# Product Release: Update to Stainless Steel Handle

**Date: 1-02-09**

**To: Implant Direct Customers**

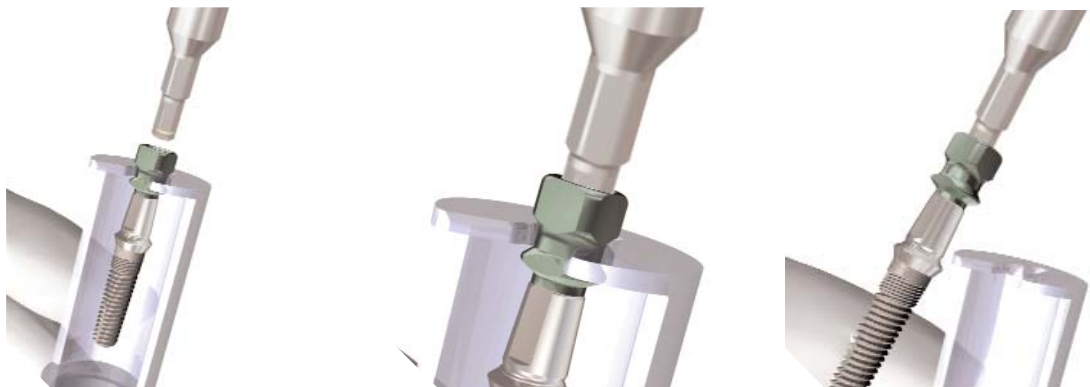
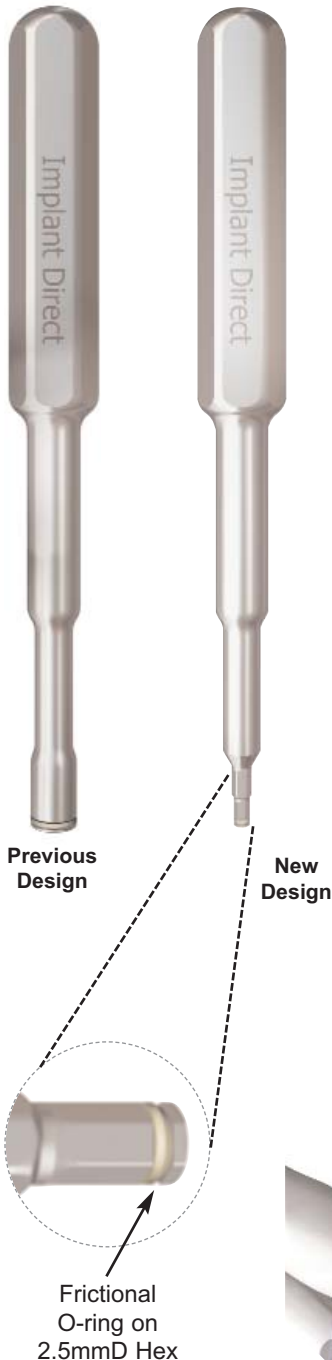
Implant Direct introduces the new and improved version of the Stainless Steel Handle. Previously referred to as the [SSH] having a design feature that encapsulated the top of a fixture mount, the new [SSH2.5] has a 2.5mmD hex tip. The 2.5mmD hex is designed with a sterilizable surgical plastic (PEEK) split O-ring at its apical end. During insertion of the tip of the handle into the mating hex connection (either fixture mount or implant), the O-ring will compress and create a frictional contact with the internal walls. This frictional connection between the two mating surfaces allows the clinician to carry the corresponding implant assembly to the surgical site by hand. This handle has the identical connection as the updated version of the HT2.5, HT2.5S tools and HD2.5 drill.
